Class II Permissive Change Letter

Date: Jul. 13, 2021

FCC ID: **XMF-MID7018**

Change to
PCB of 6.95 inch

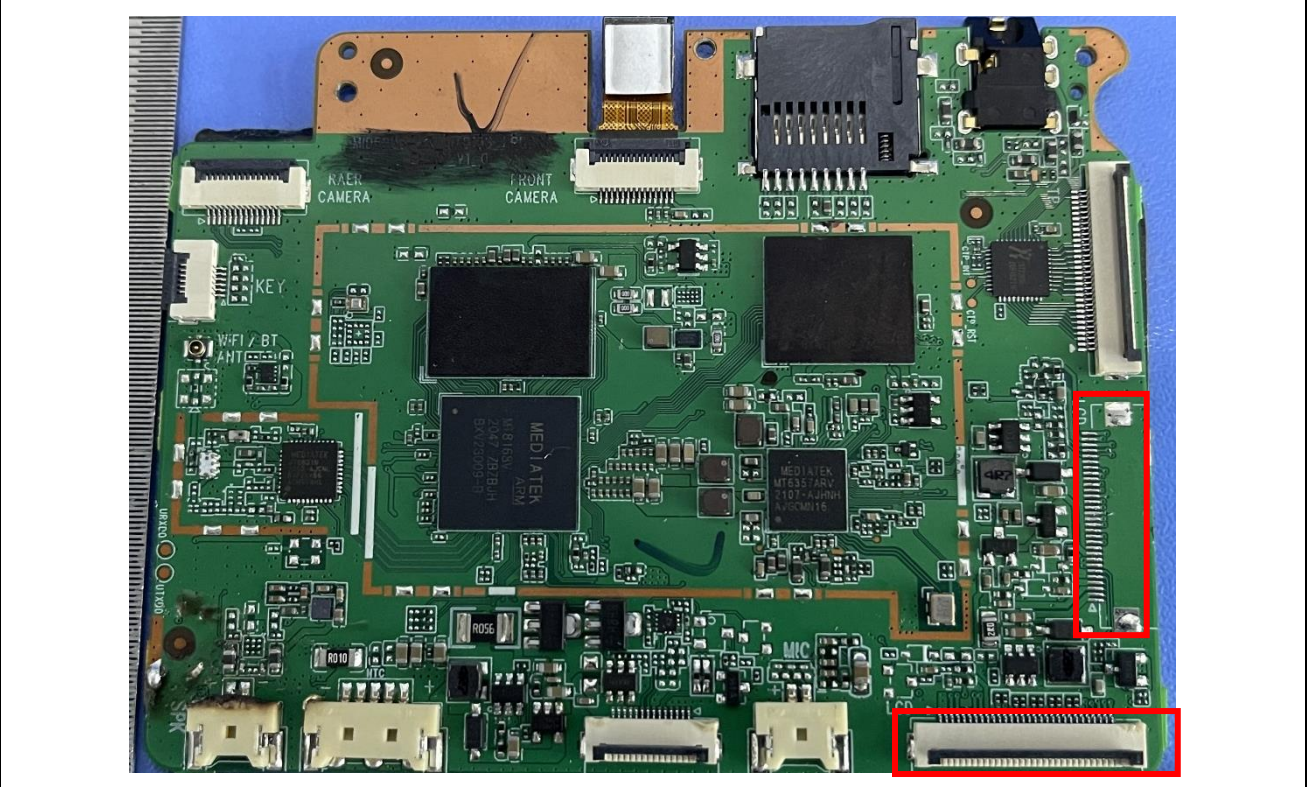
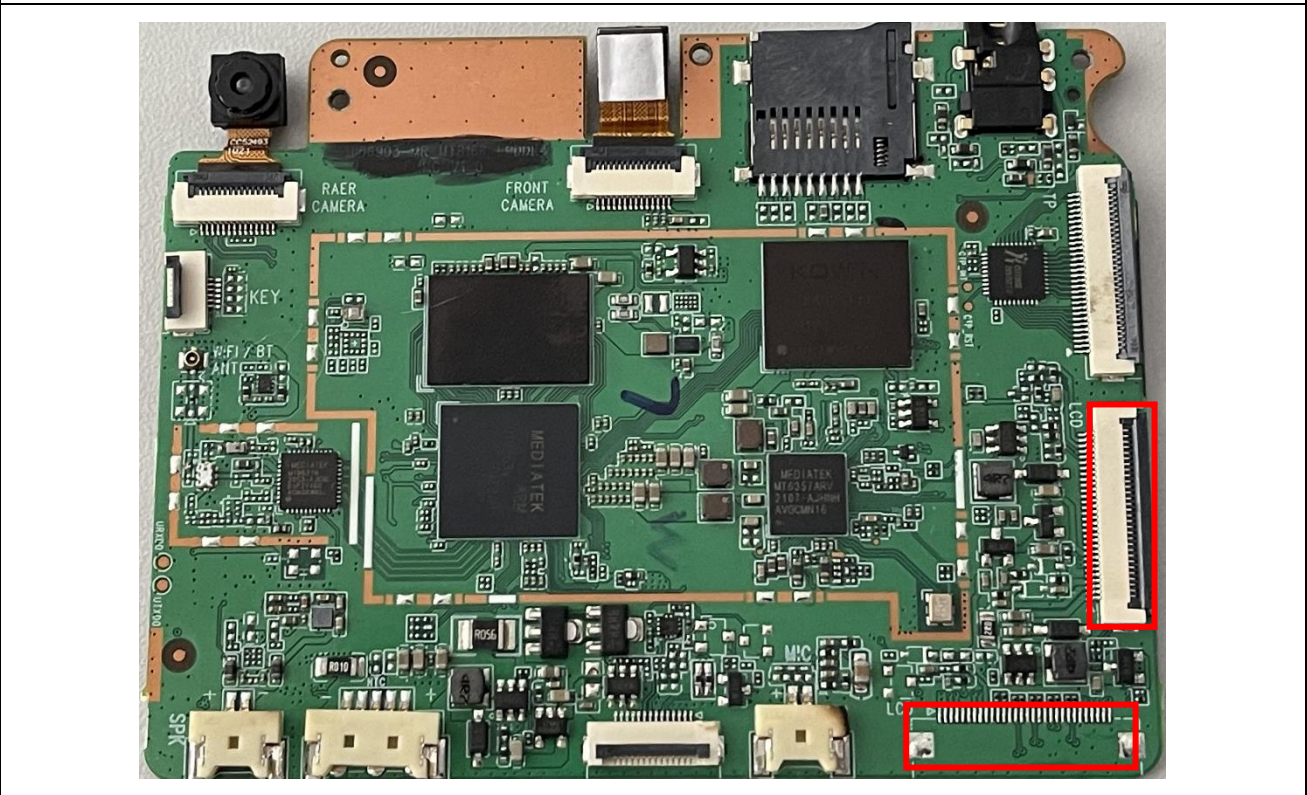
- 1, The width of the board card is 3mm, and the positions of the speakers, batteries and USB adapter sockets are moved down.
- 2, Add compatible loudspeaker power amplifier.
- 3, Remove previously compatible unused charging ICs and move the OTG function circuit over.
- 4, MIC socket moved to the center.
- 5, Added 6.95-inch screen interface.
